PUBLIC INTEREST TECHNICAL REVIEW FOR GROUNDWATER APPLICATIONS

TO: Water Rights Section Date: 9/10/2025
FROM: Groundwater Section Byron Ebner
Reviewer's Name
SUBJECT: Application G - 19490 Supersedes review of _____

Applicant's Name: Ivan Barsukoff County: Clackamas
Applicant(s) seek(s) 0.67 cfs from 1 well(s) in the Willamette Basin,
Molalla-Pudding River subbasin
Proposed use Primary Irrigation Seasonality: 5/1 – 9/30

ATTACHMENTS:**Well Location Map**

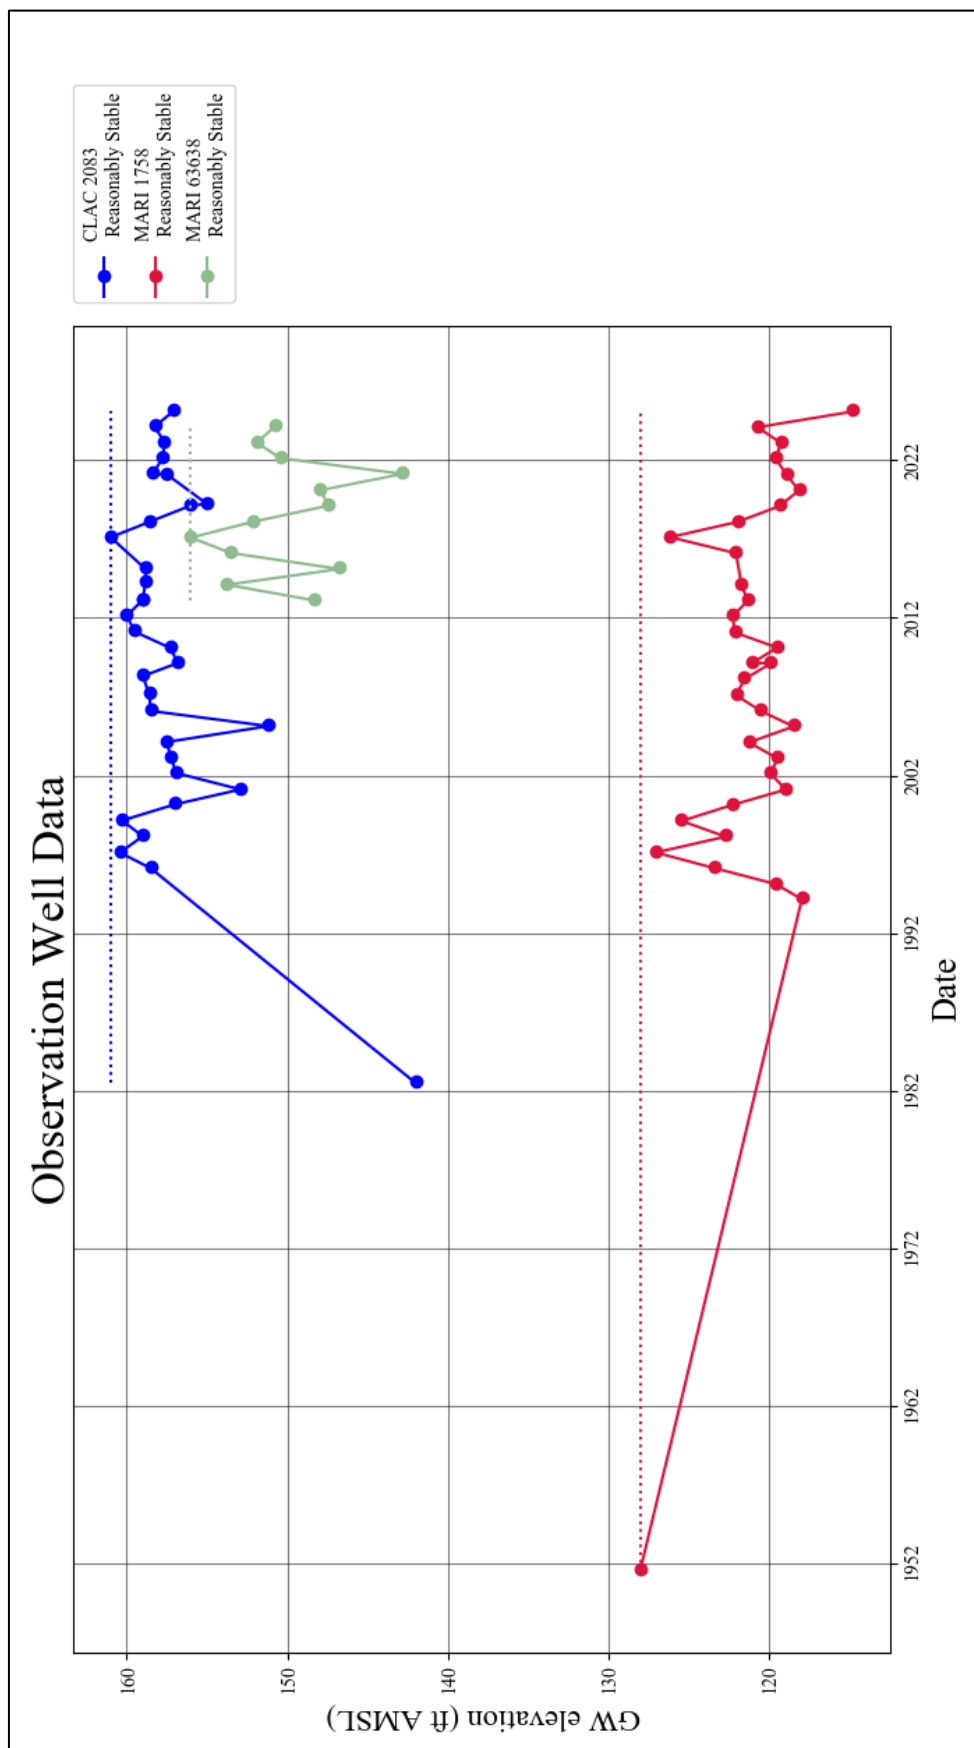
Comments: Since the proposed POA hasn't been constructed yet, 3 representative wells were chosen due to their placement around and their proximity to the proposed POA. These wells all seem to be completed in the Middle Sedimentary Unit of the Willamette Aquifer. CLAC 2083 is the closest well to the proposed POA and is located approximately 2960 ft NE, followed by MARI 1758 located approximately 7360 ft NW of the proposed POA, and MARI 63638 the furthest away approximately 10940 ft SW of the proposed POA.

Theis Time-Drawdown Worksheet

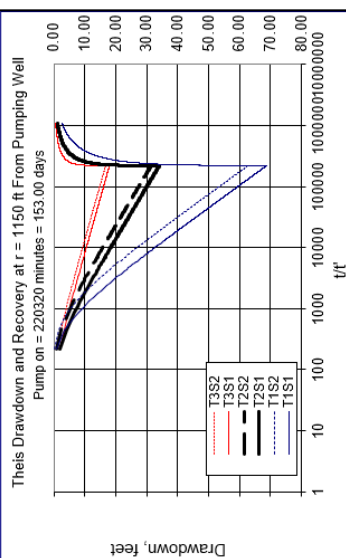
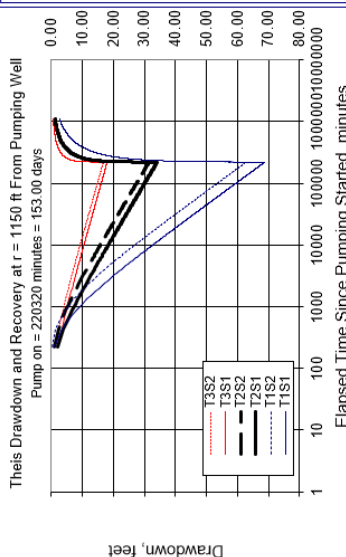
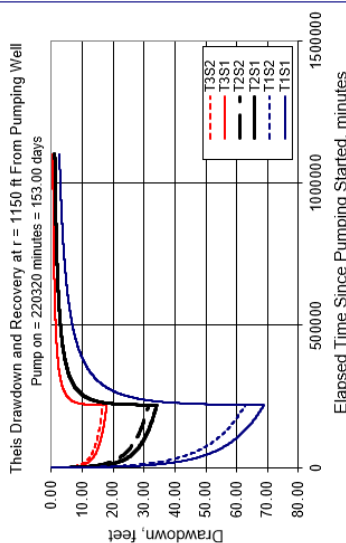
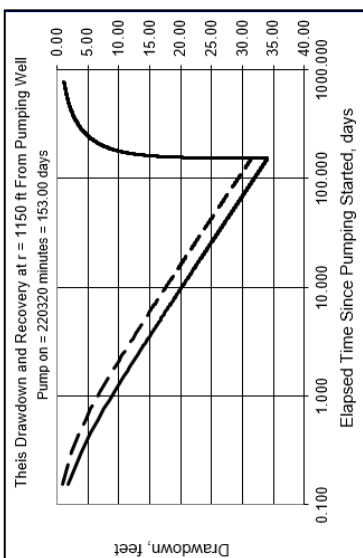
Comments: The nearest GW right is GR-1244 (CLAC 2154) and is 1150 ft SE of the proposed POA. A Theis (1941) drawdown analysis was conducted to assess potential well-to-well interference that may occur due to pumping from the proposed POA. Hydraulic parameters used for the analyses were pulled from pump test reports, Conlon et al. (2003) & (2005), Iverson (2002) and Woodward et al. (1998). Assuming constant use for the requested period of use, drawdown estimates ranged from 16.72 – 68.79 ft (analysis included as figures below). Drawdown from GR-1244’s pumping was estimated to be 17.3 – 80.08 ft. CLAC 2154 has 84 ft of water column according to a SWL measurement from the well report. Since it is unlikely that constant use at max rate will occur, the lower end estimates likely are more accurate.

Stream Depletion Modeling for Butte Creek

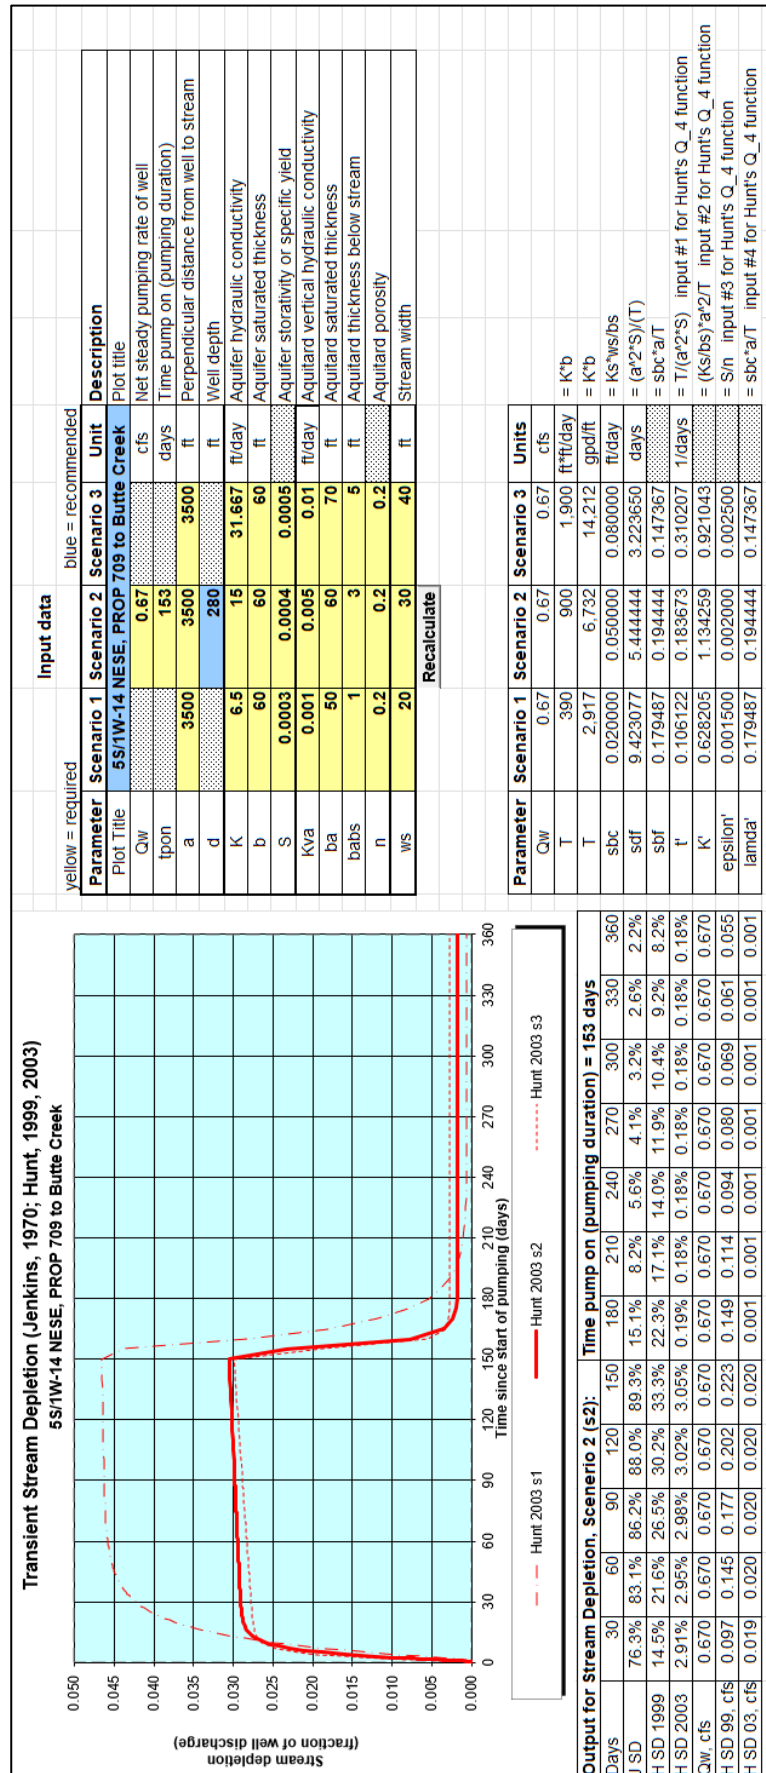
Comments: Due to the presence of the Willamette Silt Unit from the land surface to the Middle Sedimentary Unit, Hunt (2003) was chosen to estimate streamflow depletion for the above streams. Streamflow depletion estimates from the Hunt (2003) model assume constant use at maximum rate and use hydraulic parameters from pump test reports, Conlon et al. (2003) & (2005), Iverson (2002) and Woodward et al. (1998). The results of these model runs for Butte Creek and Rock Creek are below and included as figures at the end of this review. Estimated percent of pumping rate from stream depletion of Butte Creek at 150 days is 3 – 4.7% . Estimated percent of pumping rate from stream depletion of Rock Creek at 150 days is 0.04 – 7.4%. Depletion of local surface water will be buffered by the low vertical hydraulic conductivity and substantial thickness of fine-grained sediments between the relevant water-bearing zones and local streambeds. However, there will still be some depletion of surface water. Net impacts will be small at the onset of pumping but will increase with time until a new equilibrium between local recharge and discharge is reached, at which time surface water depletion is anticipated to be relatively constant throughout the year. Water isn’t available in either WAB for the requested period. Water Availability Analysis included as figures.
